**BOILER REPLACEMENT  
HADLEY ELEMENTARY SCHOOL  
SWAMPSCOTT, MASSACHUSETTS**

**ADDENDUM NO. 2**

Addendum Number 2  
December 7, 2016  
Page 1 of 19

HVAC  
BOILER ROOM UNIT HEATER  
 SCALE: 1/4"=1'-0"

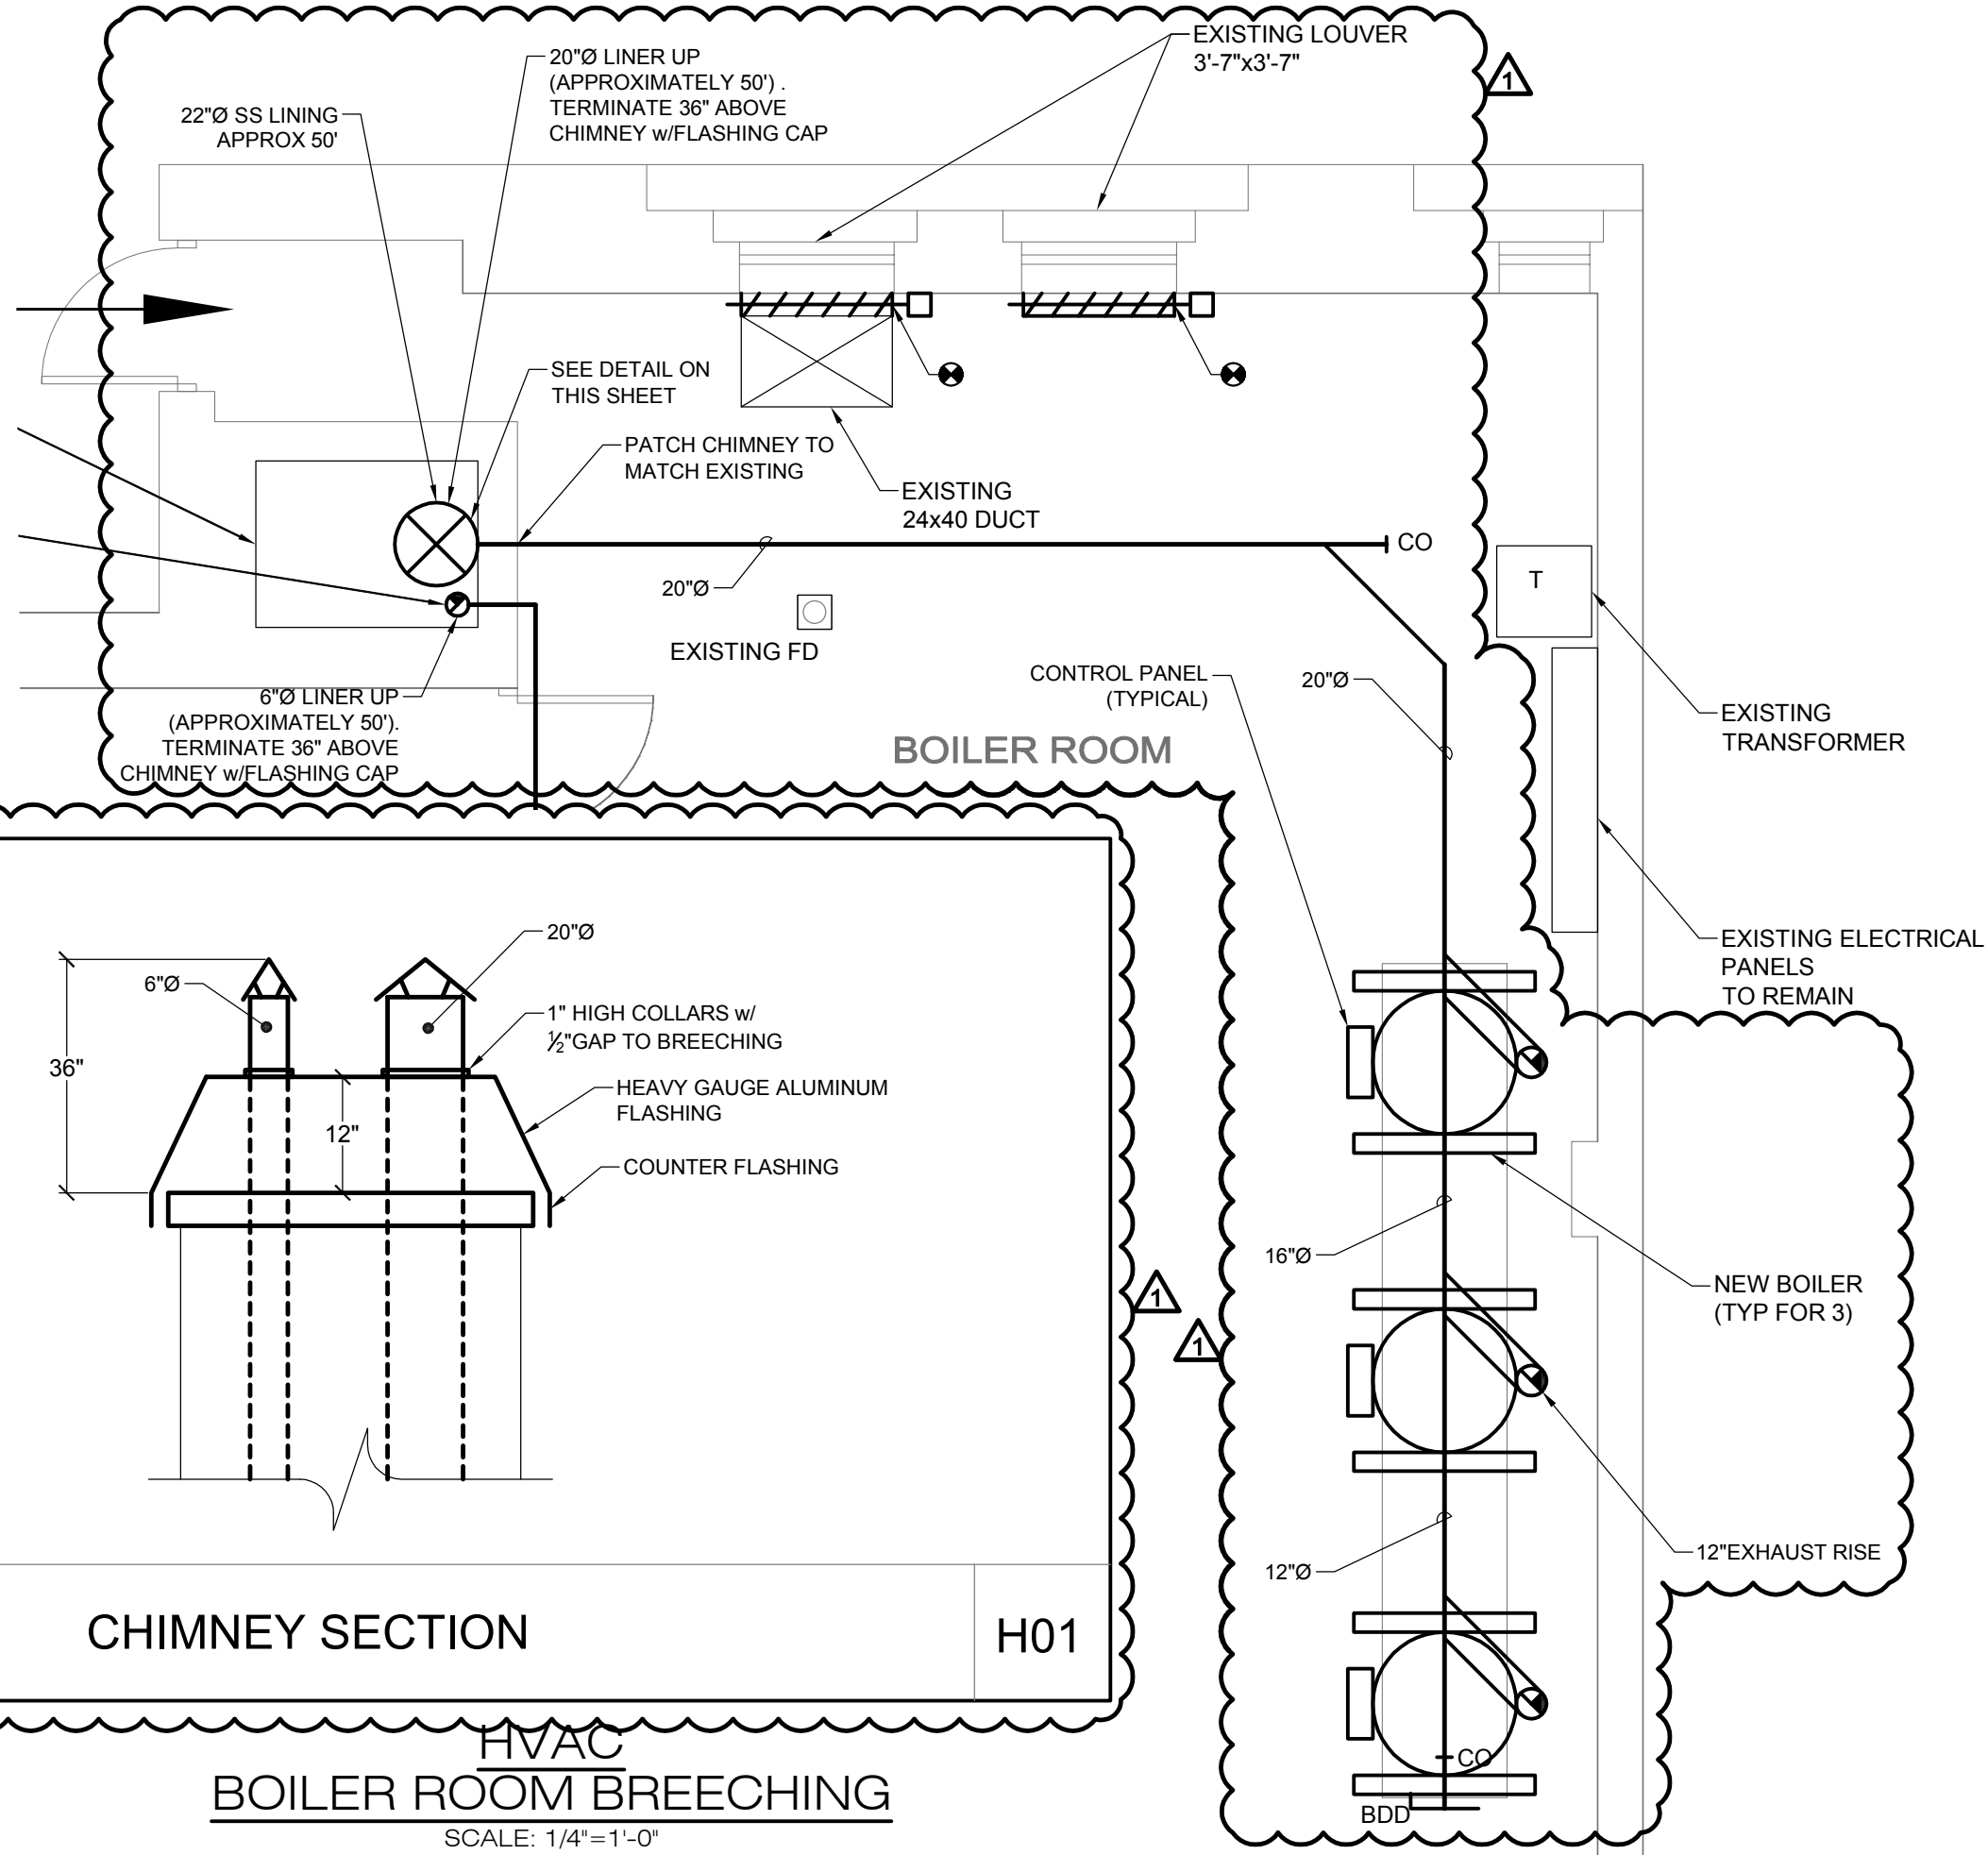
1. SKH-1: Boiler Room Unit Heater to drawing H2.02.
2. SKH-2: Boiler Room Breeching to drawing H2.03.
3. SKH-3: Boiler Feed & Unit Heater Schedules to drawing H8.00
4. SKE-1: Boiler Room Demolition and New Work Part Plans to drawing ED2.00 and E2.00.
5. SKE-2: Electrical Schedule to drawing E9.00.

**PLUMBING  
BOILER ROOM NEW WORK PLAN - PHASE 1**  
SCALE: 1/4"=1'-0"

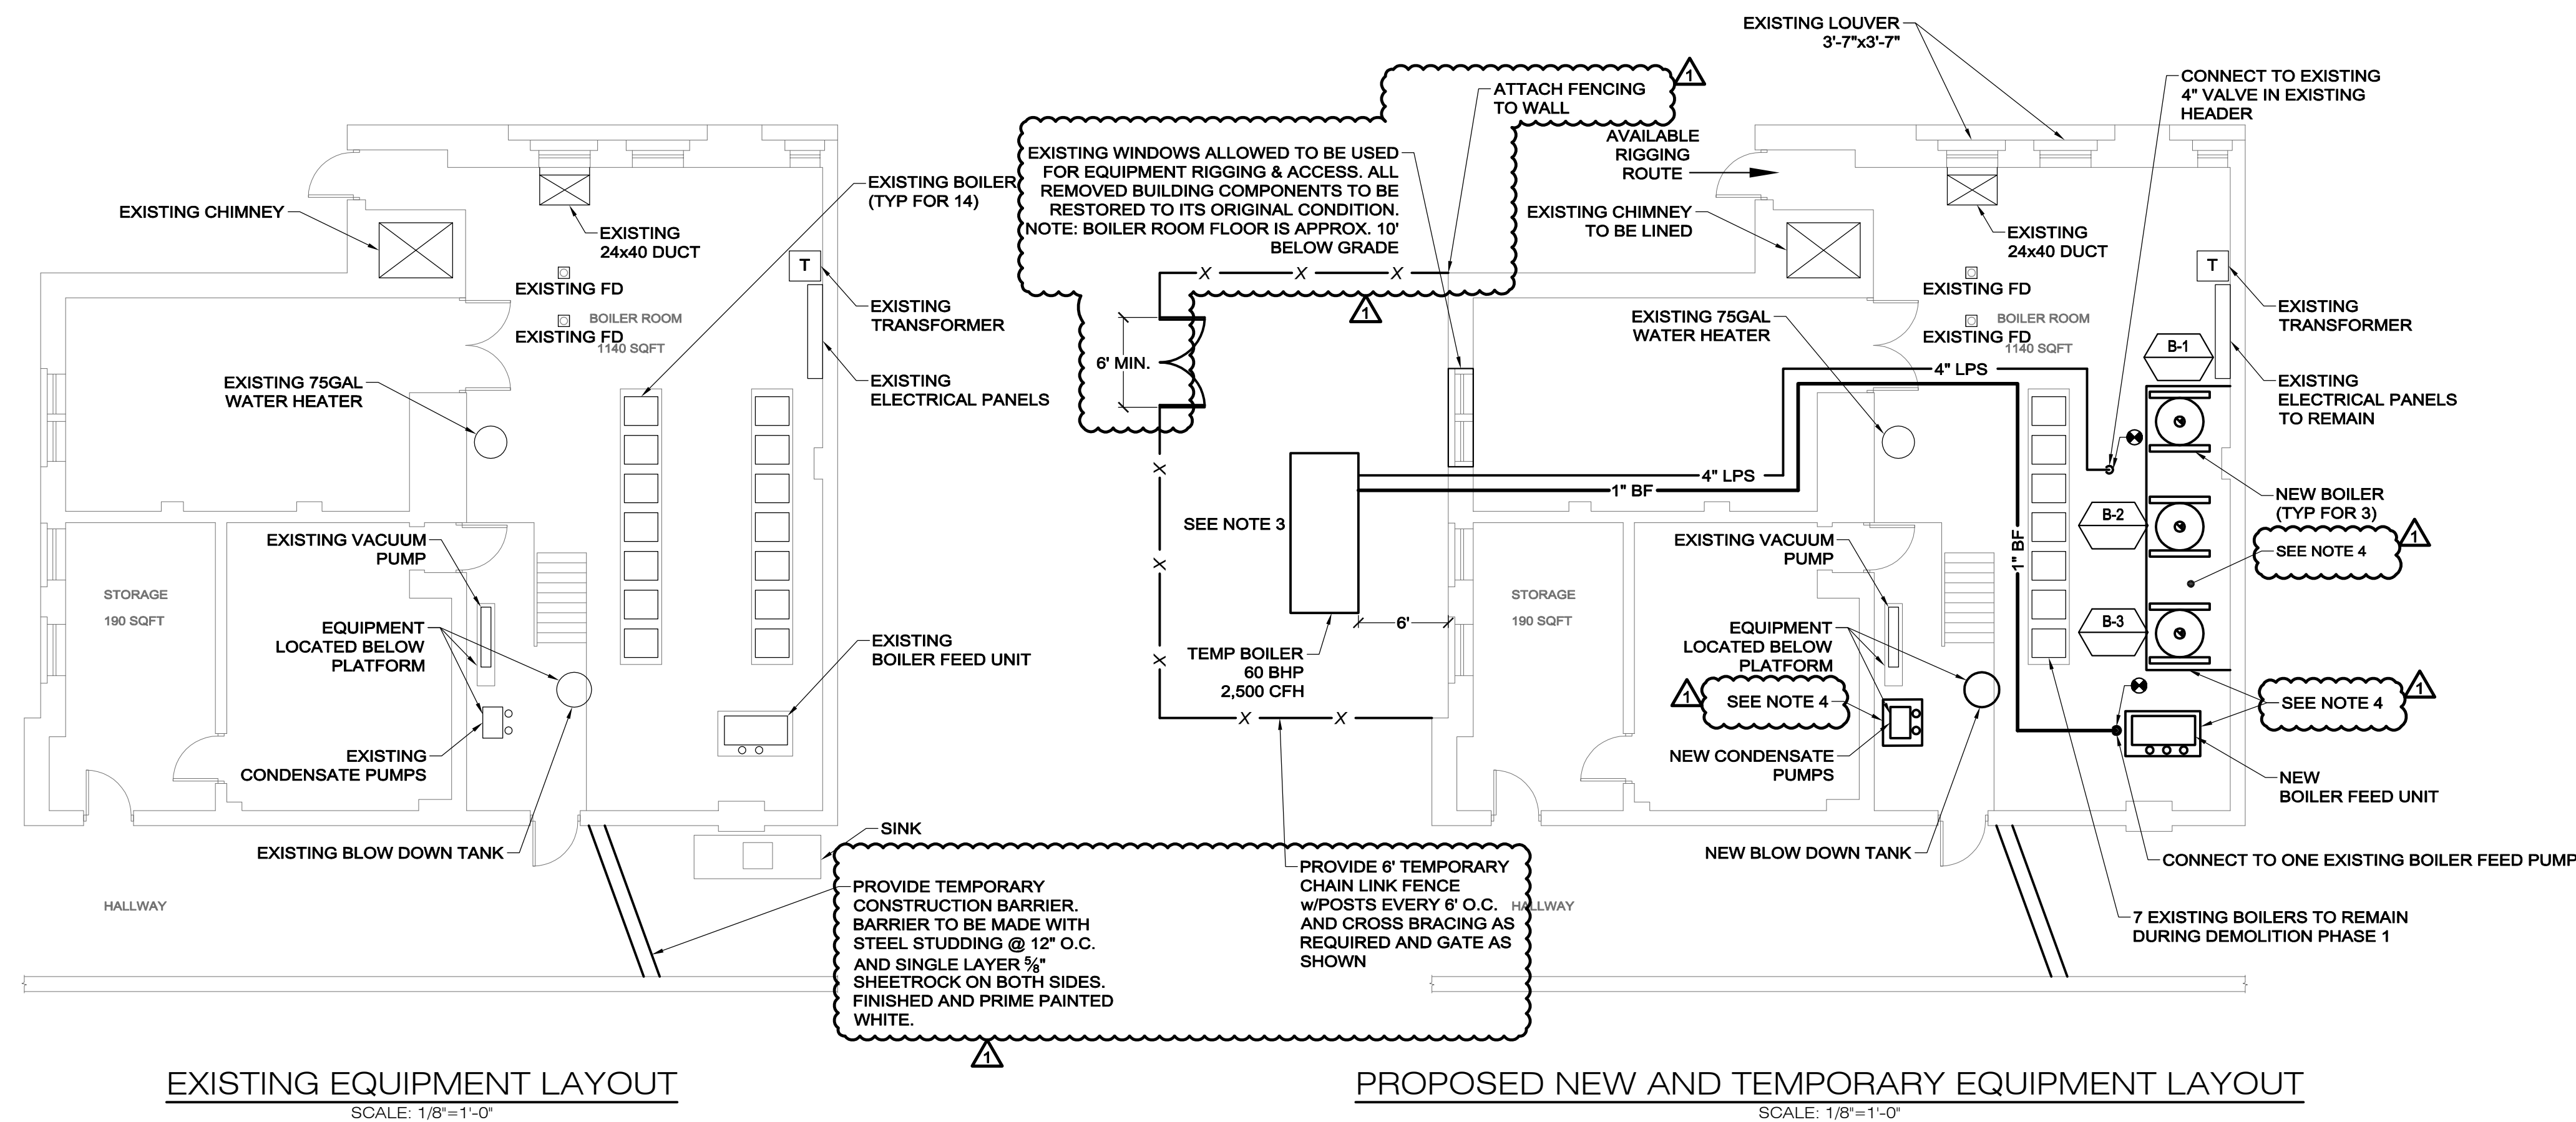
1. P2.00 – Plumbing Boiler Room New Work Phase 1 with P2.00 – Plumbing Boiler Room New Work Phase 1 Revision 1 dated 12/7/16.
2. H0.01 – HVAC Boiler Room Equipment Plan & Temp Boiler with H0.01 – HVAC Boiler Room Equipment & Temp Boiler Revision 1 dated 12/7/16.
3. H6.00 – HVAC Controls with H6.00 – HVAC Schematic Revision 1 dated 12/7/16.

- 2.1 Clarification narrative for Drawings PD2.00 and PD2.01:  
Plumbing Construction and Phasing;

The intent of these drawings is to illustrate the proposed phasing of this project consisting of Phase 1 demolition and new work and Phase 2 demolition and new work.

Phase 1 - Demolition

Provide temporary 4" gas line from downstream of the existing gas meter and pressure regulating station to the temporary boiler as located on the drawings. This gas piping shall be mounted on the exterior of the building and 72" above grade. Piping shall be tested and inspected prior to connection to the temporary boiler then removed when the temporary boiler is removed. All damage to the building from the installation of the temporary gas piping shall be repaired to match existing.

Provide gas piping disconnection of seven (7) boilers as indicated on the drawings to be demolished first. Provide gas piping (4") removal within boiler room as indicated on the drawings.

Provide floor drain and blowdown tank discharge power cleaning to restore operation.

Phase 1 – New Work

Provide gas booster and make all required gas piping connections. Provide gas piping connections to the new boilers (3). Test and inspect all new gas piping for energizing.
